P&Z CASE # SP2021-032 P&Z DATE 12/14/21 CC DATE APPROVED/DENIED
ARCHITECTURAL REVIEW BOARD DATE HPAB DATE PARK BOARD DATE

PROJECT NUMBER: SP2021-032
PROJECT NAME: Site Plan for Payne Chiropractic
SITE ADDRESS/LOCATIONS: 1213 N Goliad St #B

CASE CAPTION: Discuss and consider a request by Jeff Carroll of Carroll Architects, Inc. on behalf of Timothy Payne of BT Management 11, LLC for the approval of a Site Plan for a Medical Office Building on a 0.47-acre parcel of land identified as Lot 2, Block 1, Elsey Addition, City of Rockwall, Rockwall County, Texas, zoned Planned Development District 69 (PD-69) for Residential-Office (RO) District land uses, situated within North SH-205 Overlay (N. SH-205 OV) District, generally south of the intersection of Sonoma Drive and N. Goliad Street [SH-205], and take any action necessary.

DEPARTMENT	REVIEWER	DATE OF REVIEW	STATUS OF PROJECT
PLANNING	Andrew Reyna	11/17/2021	Approved w/ Comments

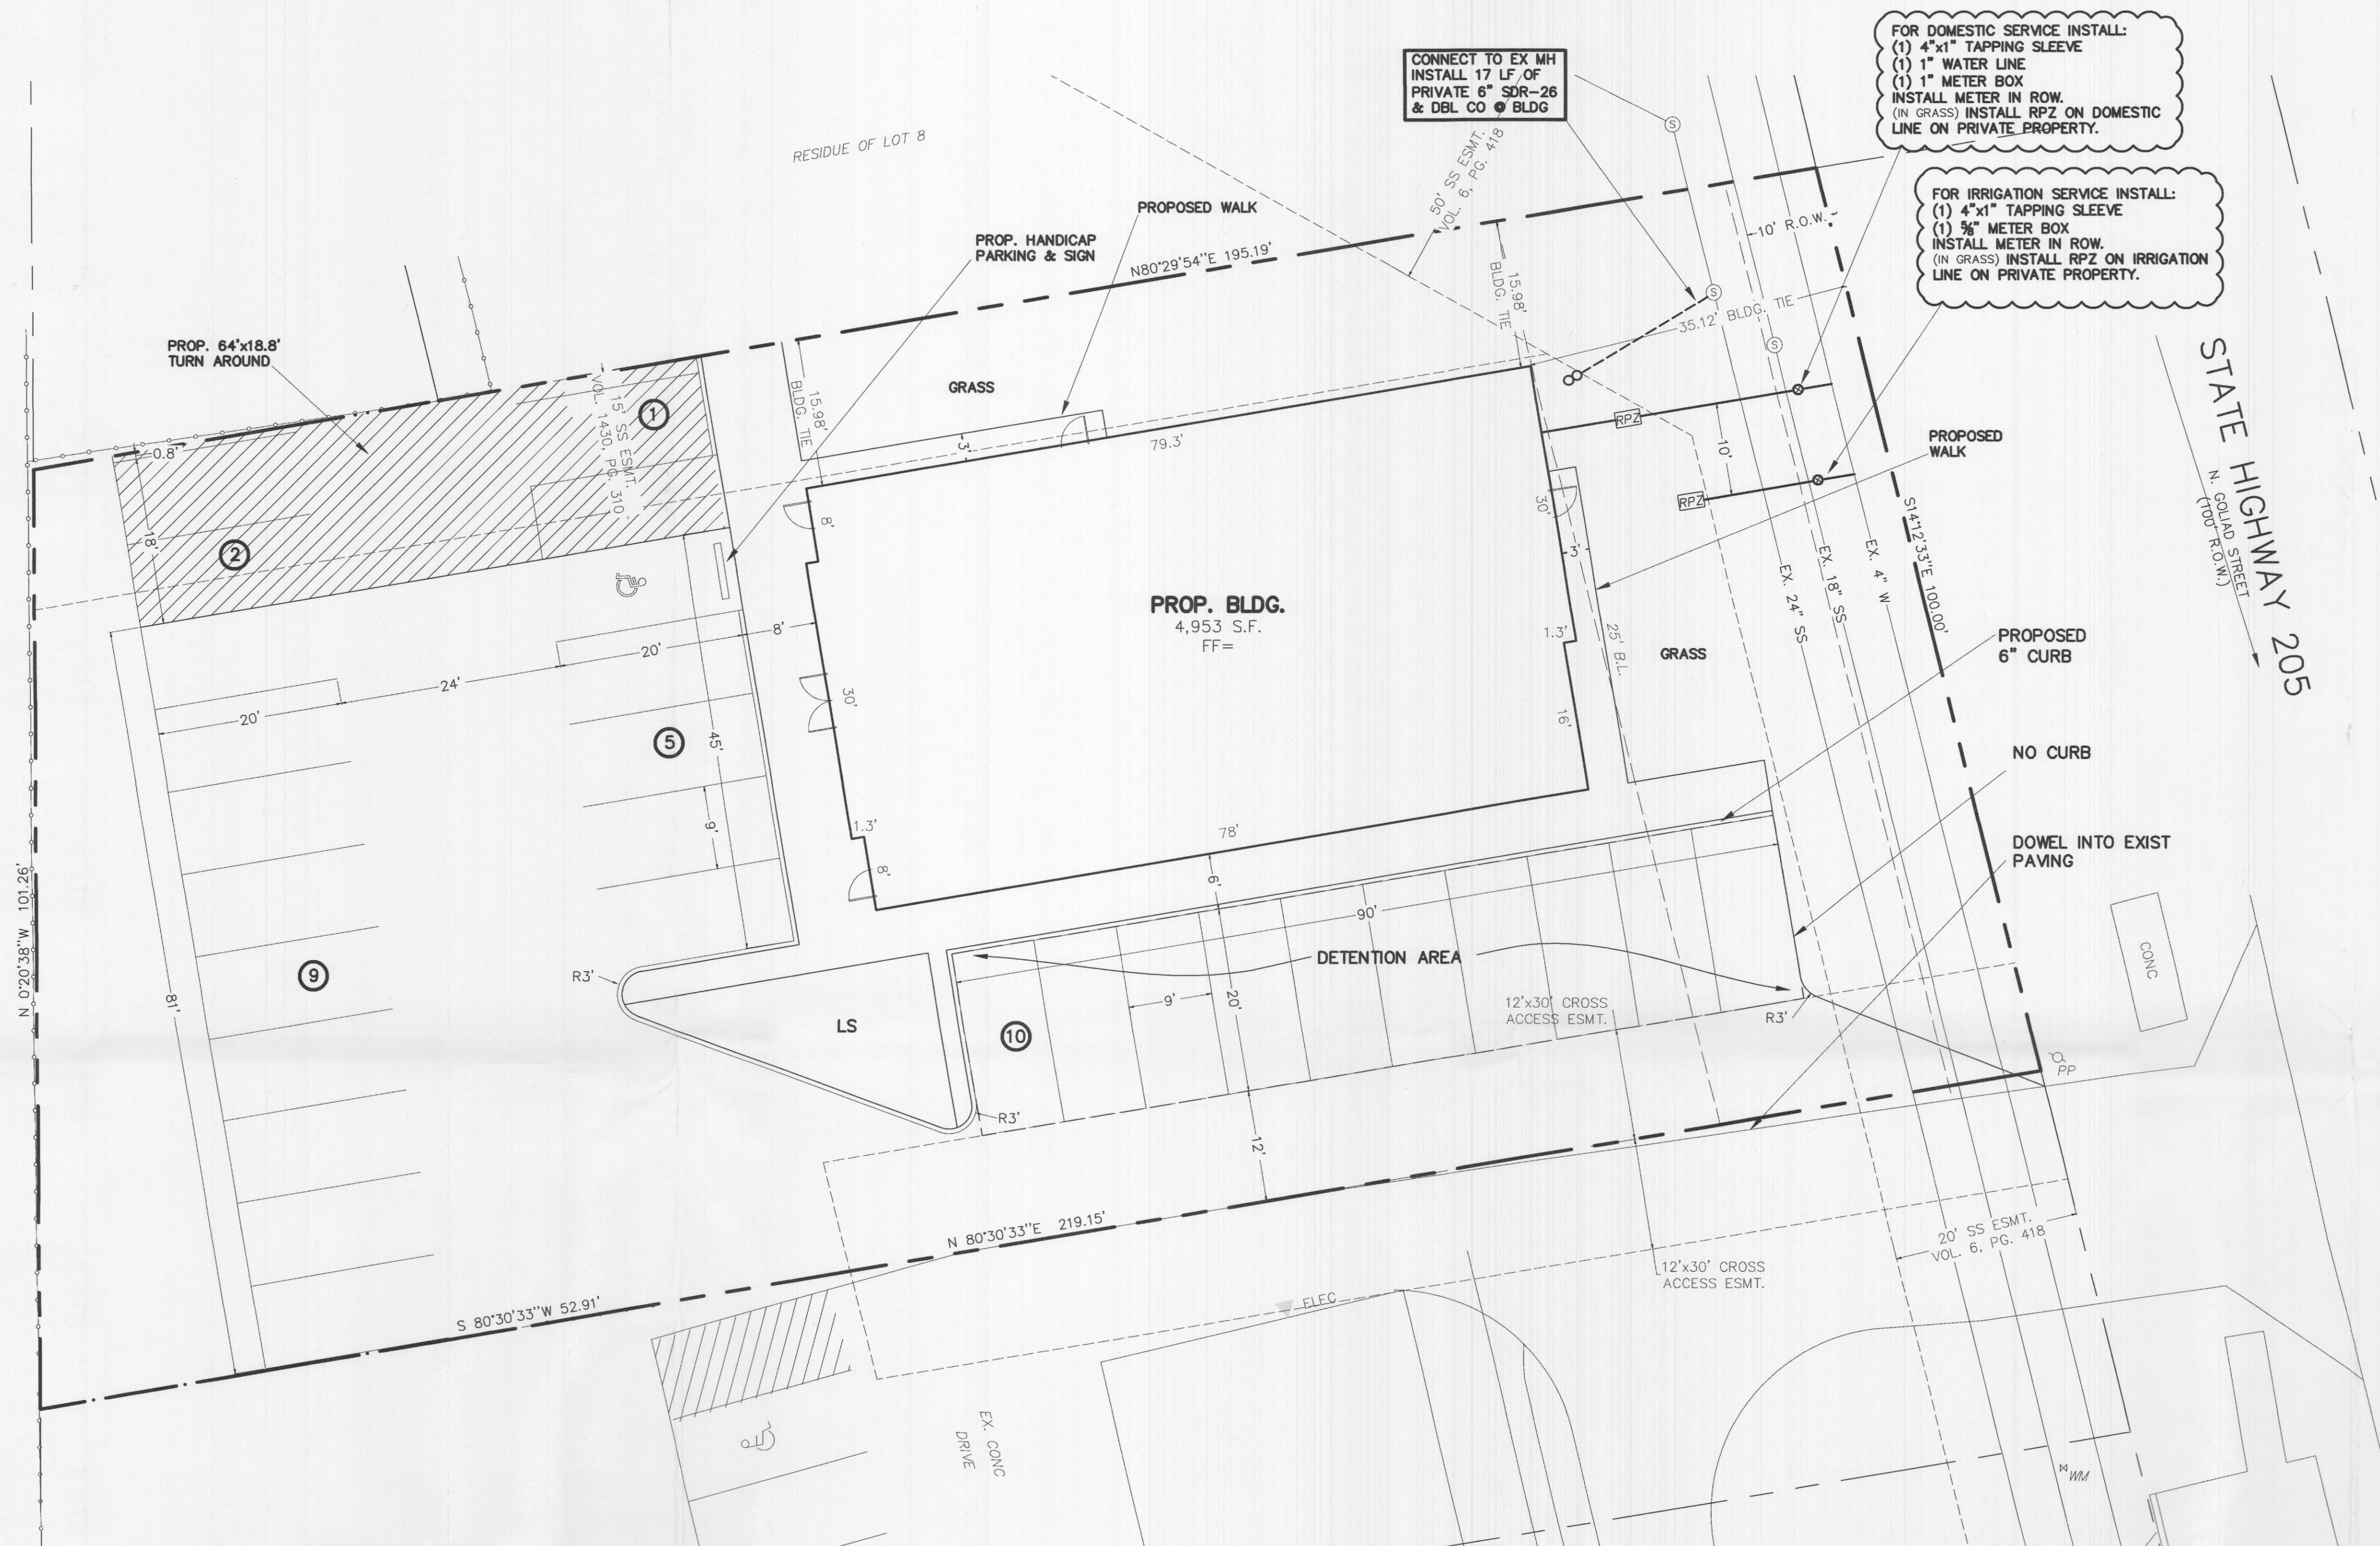
M.13 Site Plan. Please make the following clarifications on the site plan to ensure staff can properly review this project and convey all of the required elements to the City's boards and commissions (§01.02, Art. 11, UDC):

- 2) Two front parking spots along the southeast corner of the proposed building fall within the front building setback and will need to be removed or relocated per the development standards identified in Planned Development 65 (PD-65) District and Residential Office (RO) DISTRICT uses. (§07.03, of Art. 05, UDC)

- 3) Proposed parking in proposed turnaround needs to be removed, no parking spots are allowed in turn around areas.
- 4) Per Planned Development District Planned Development 65 (PD-65) District, no specific parking requirements identified, Provide parking table indicating the total number of required parking spaces by use, the total number of required handicapped parking spaces and the total parking provided. (§05.01, of Art. 06)
